A66 Northern Trans-Pennine Project

7.24 Applicant's Responses to the Examining Authority's Written Questions

**7.24 APPLICANT'S RESPONSES TO THE EXAMINING AUTHORITY'S
WRITTEN QUESTIONS**

Deadline:	Deadline 4
Planning Inspectorate Scheme Reference	TR010062
Application Document Reference	NH/EX/7.24
Author:	A66 Northern Trans-Pennine Project, Project Team, National Highways

3.3. Appendix C: PC 1.1 Approximate location of “Billy Welch straight line route” on OS background mapping and Aerial Imagery background

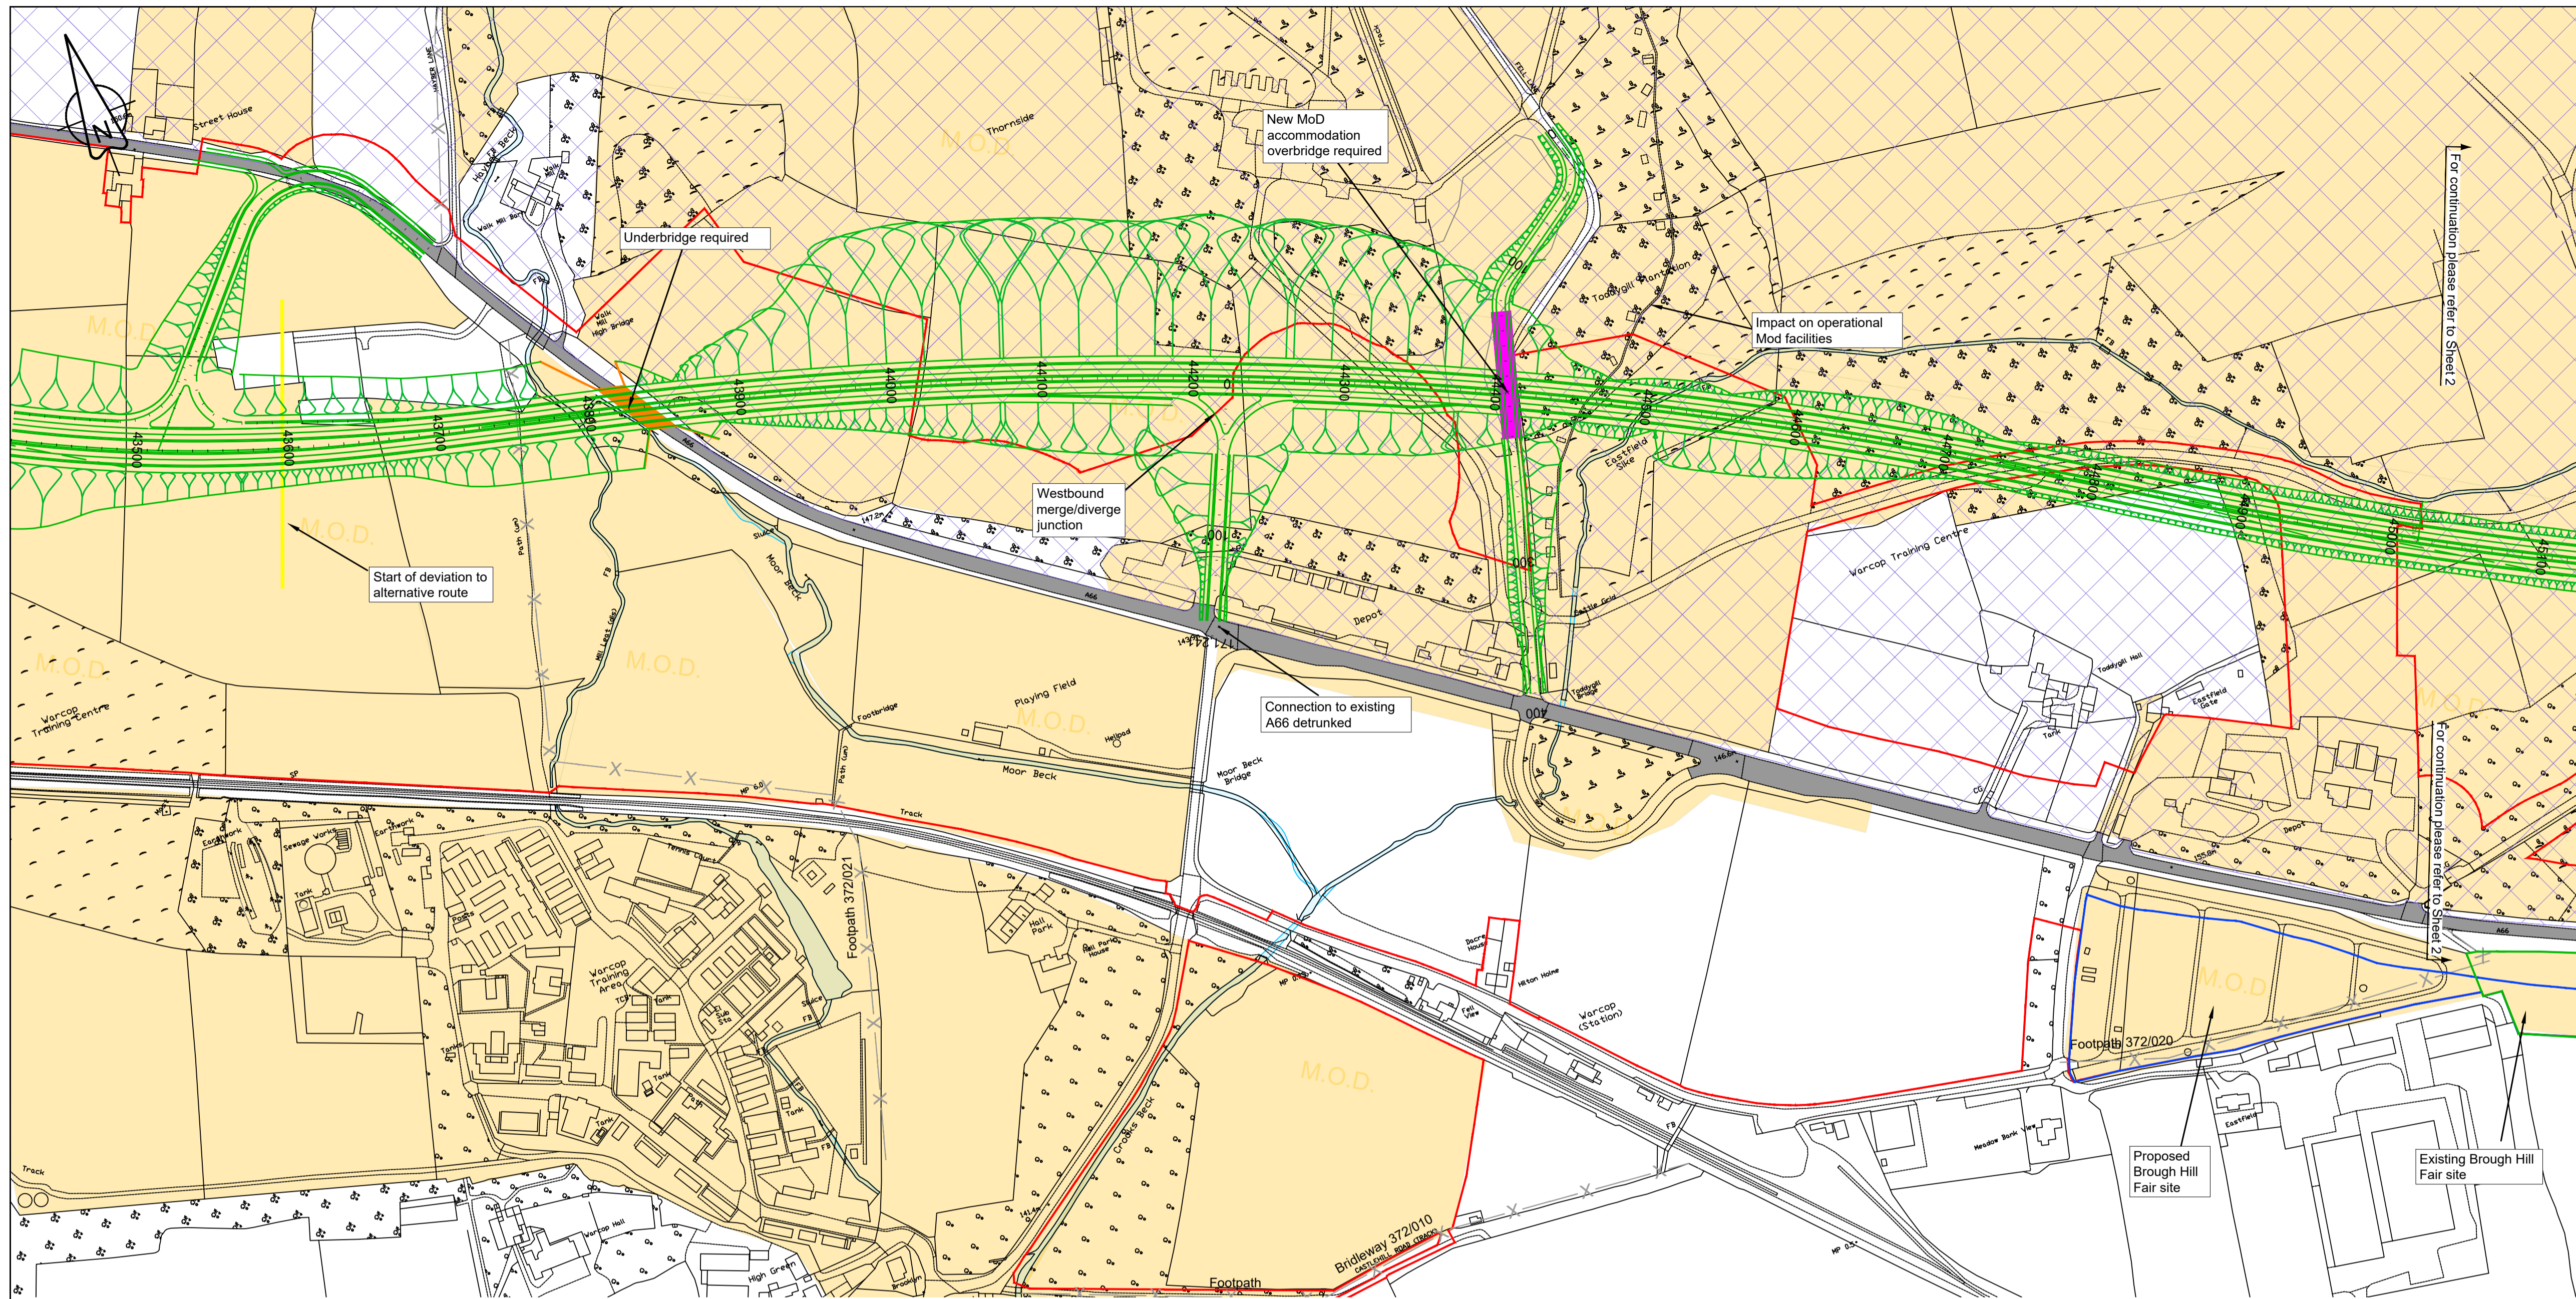
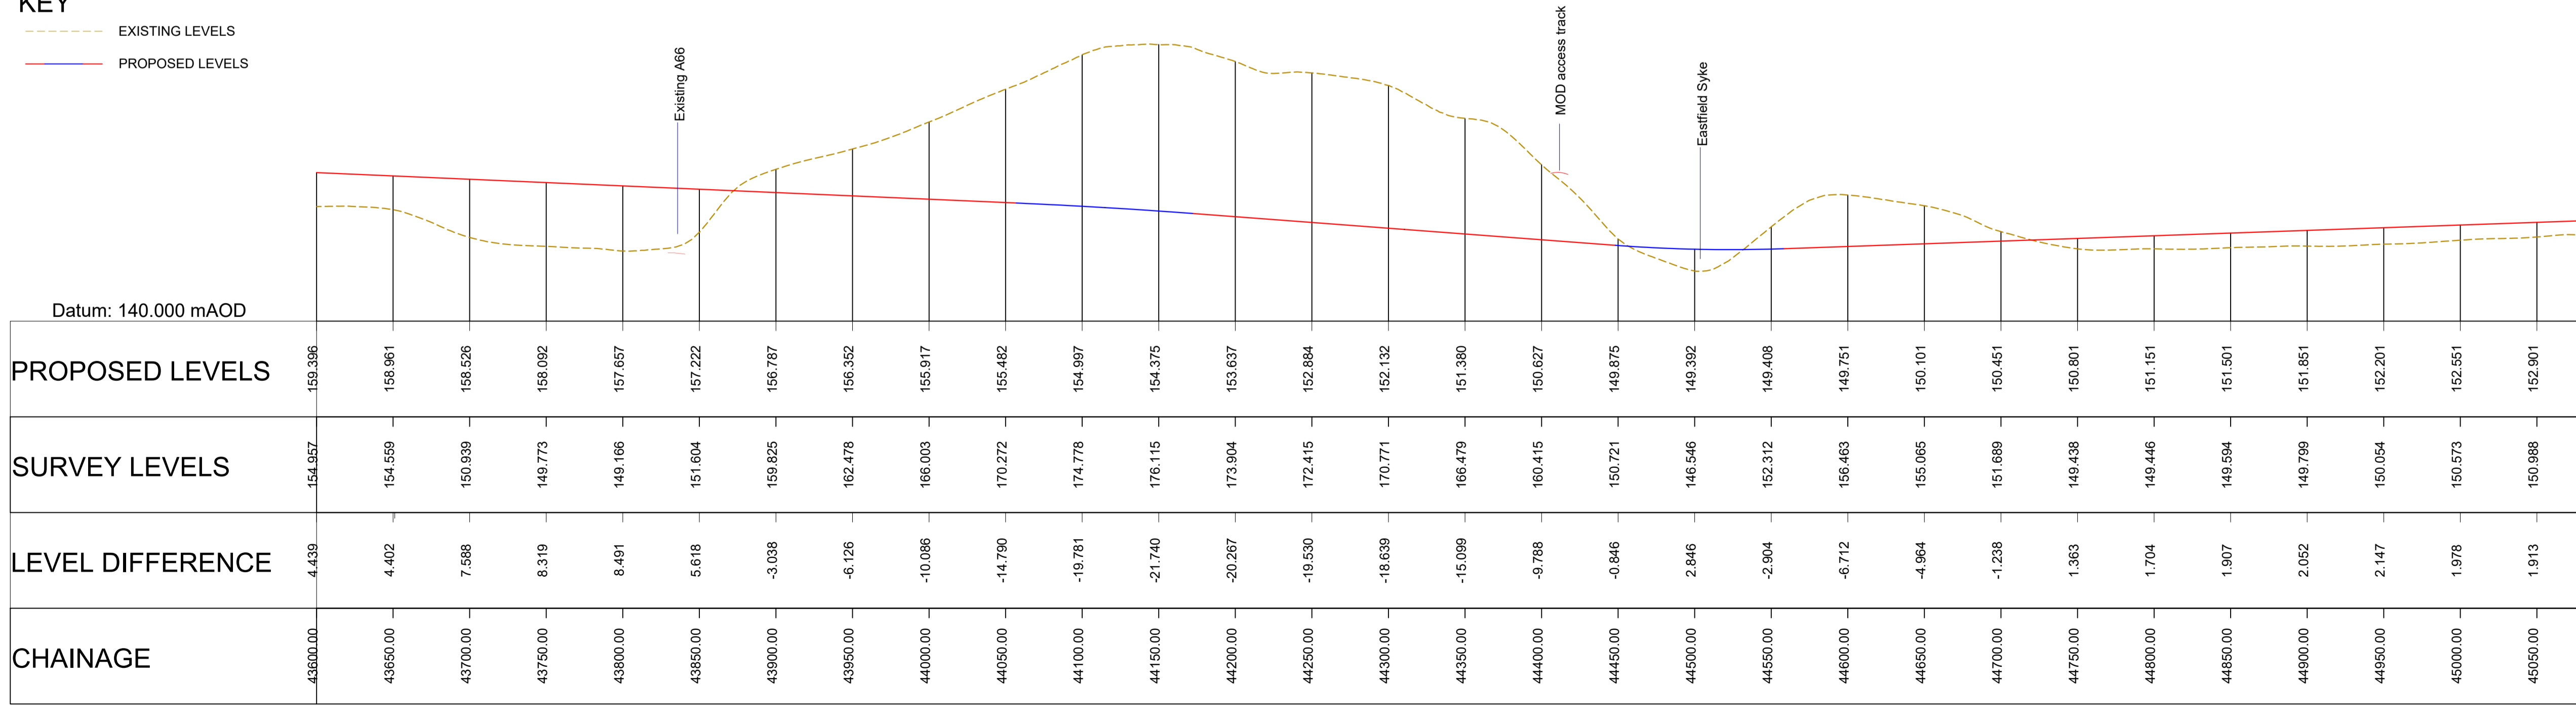
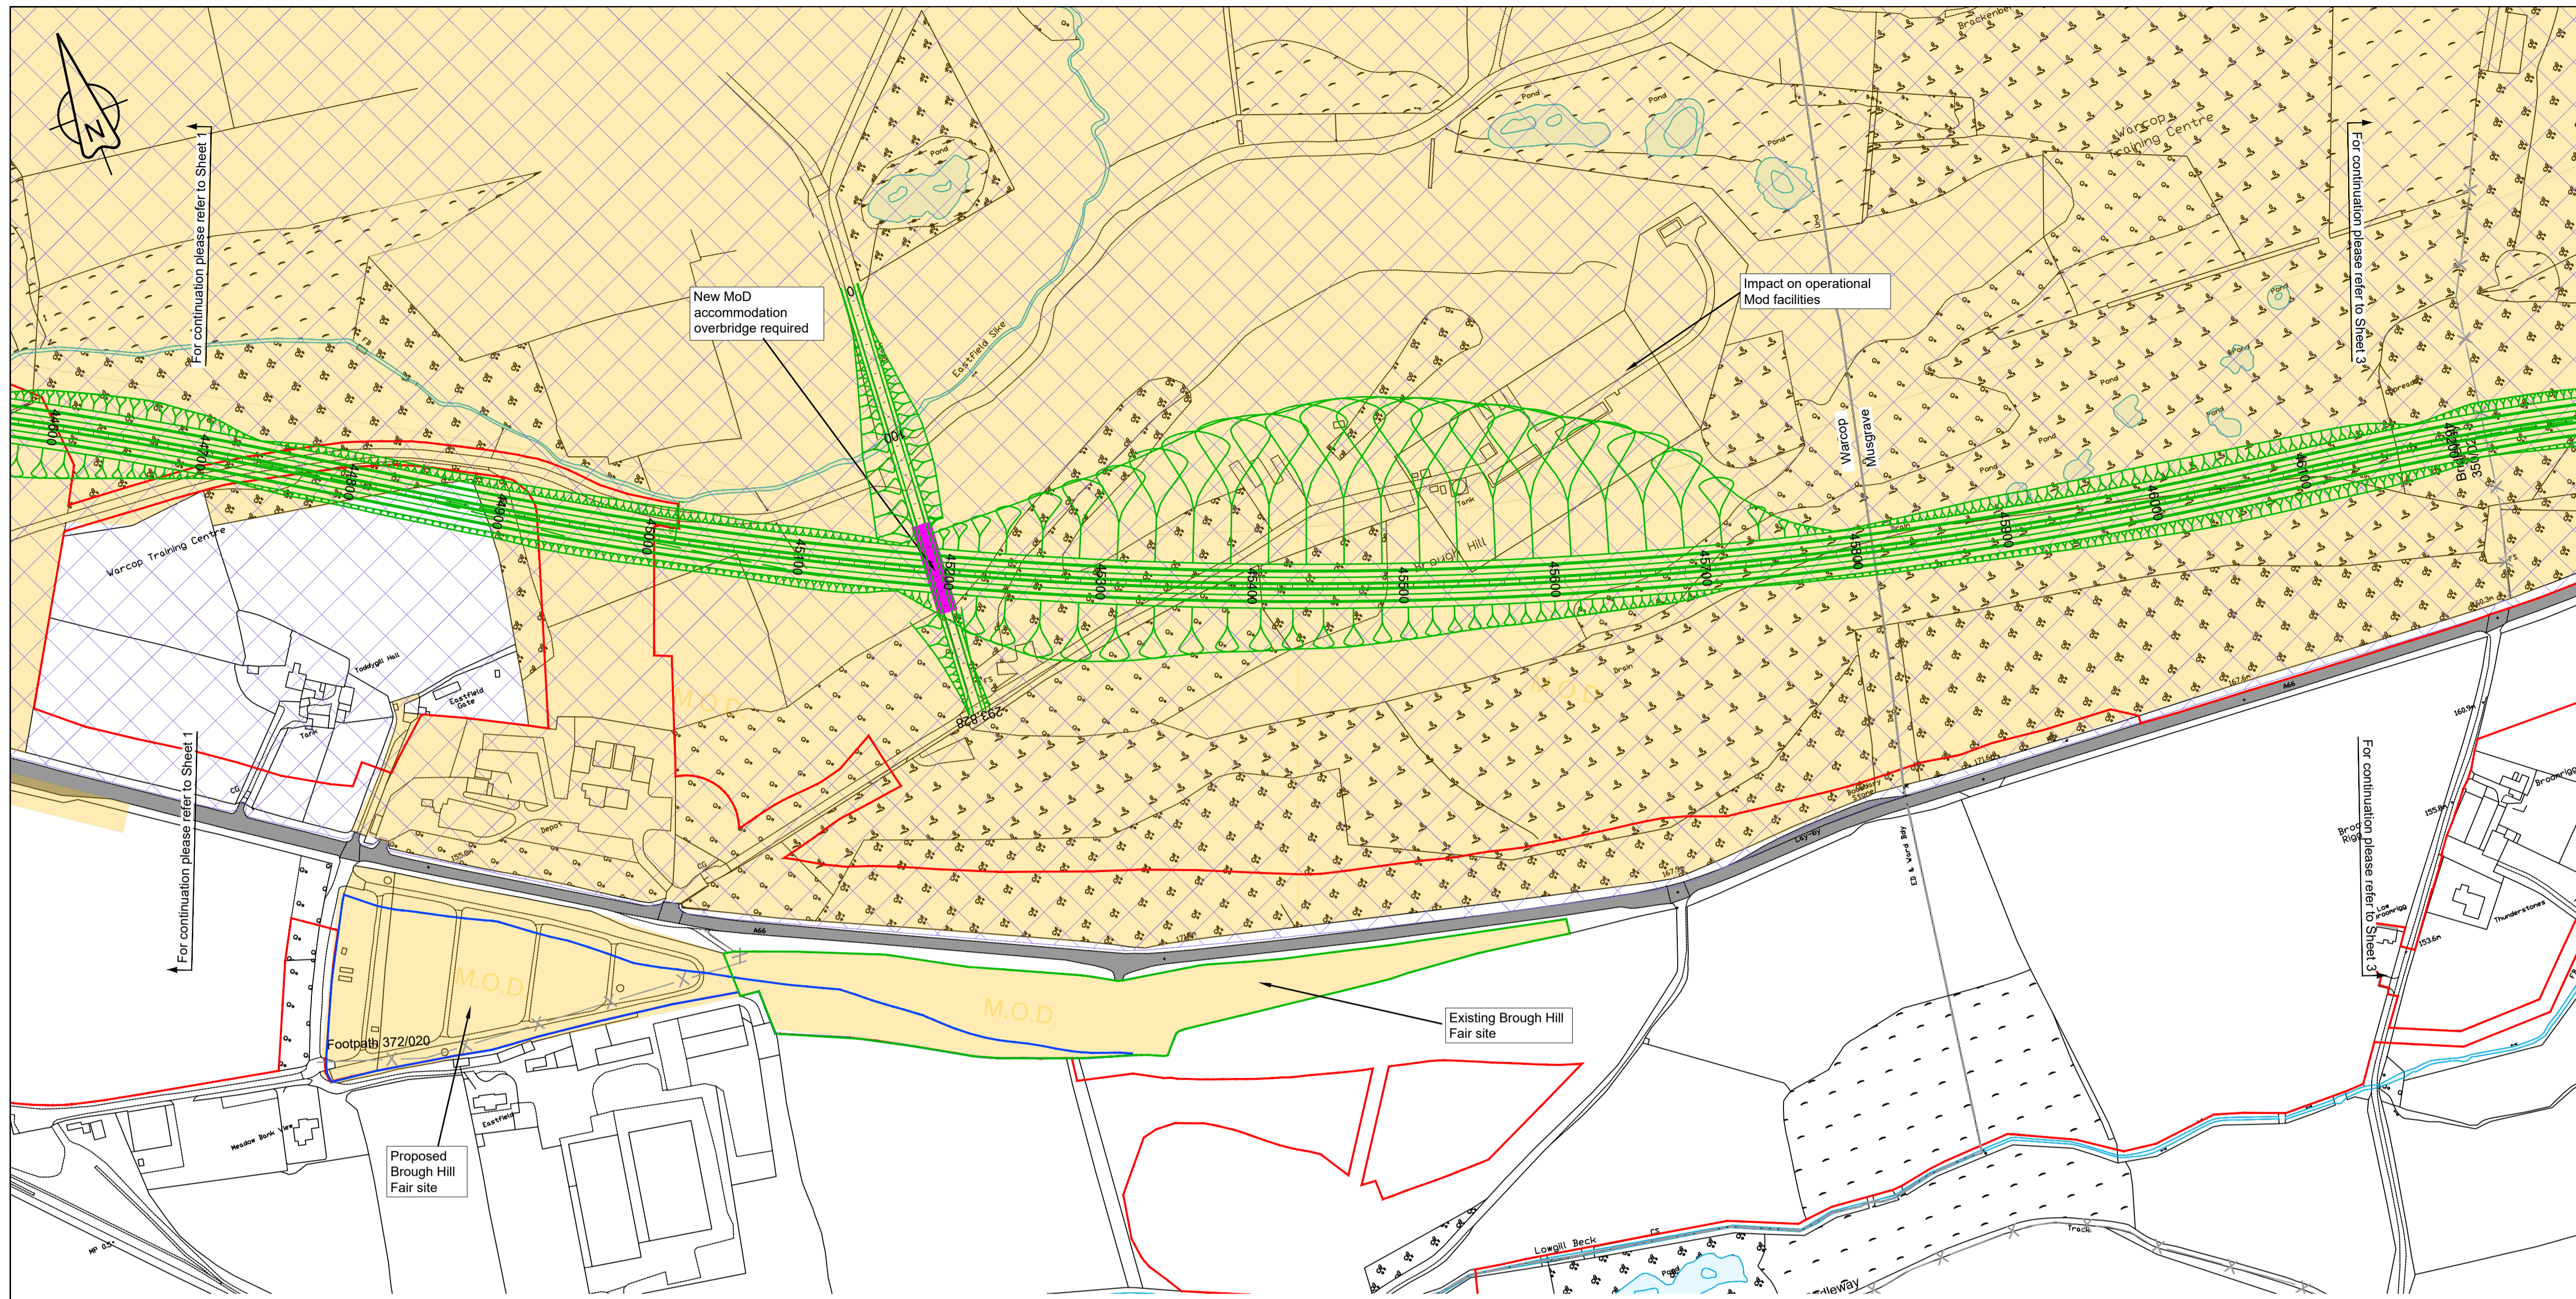
PEOPLE AND COMMUNITIES				
PC 1.1	Brough Hill Fair	<p>Applicant</p> <p>The Representative of the Gypsy and Traveller Community</p>	<p>Several Interested Parties (IPs) make mention of the "Billy Welch straight line route" to the north of the existing A66 that avoids the current Brough Hill Fair site. Provide a plan showing the approximate location of this option.</p>	<p>The Applicant has appended plans to this document, in order to assist with its response to the ExA's question.</p> <p>The first three plans in Appendix C show the approximate location of the "Billy Welch straight line route" against OS background mapping in line with the ExA's drafting request as set out in the Rule 6 letter [PD-006]. These sheets include annotations to highlight key features.</p> <p>The final plan in the set, at the end of Appendix C, shows an unannotated version of the same route against a background of aerial imagery to provide further illustrative context for the route.</p> <p>The alignment shown in the plans has been interpreted from, and therefore considered representative of, a route suggested by Interested Parties.</p> <p>An unannotated plan of this route was discussed during a meeting between the Project team and the local community, including members of the Warcop and Musgrave Parish Councils, in November 2021. As such, those sections of alignment to the west and east of the alternative represent the alignment as it was at that point in time - i.e., the proposals taken to Statutory Consultation. At this meeting, a number of alternative alignments were discussed, including a version of the updated alignment at Sandford now incorporated into the DCO design.</p> <p>Regarding what has come to be known as the "Billy Welch straight line route" (originally proposed by Mr Welch and Warcop Parish Council), meeting attendees were informed that the plan presented did not include drainage infrastructure or environmental mitigation measures, which were expected to be significant given the incursion into the North Pennines Area of Outstanding Natural Beauty. In addition, local topography would require significant earthworks, include large cuttings within operational MoD land, for the route to be constructed (as can be seen on the long sections shown on the plans included in Appendix C).</p> <p>Although this alignment would retain some local accesses, the MoD playing field and the current Brough Hill Fair site, meeting attendees were informed that due to impacts on both the AONB and operational MoD land, the Applicant did not believe this requested alternative alignment to be a deliverable proposal likely to be granted Development Consent. As such, the "Billy Welch straight line route" was not developed or considered further.</p>
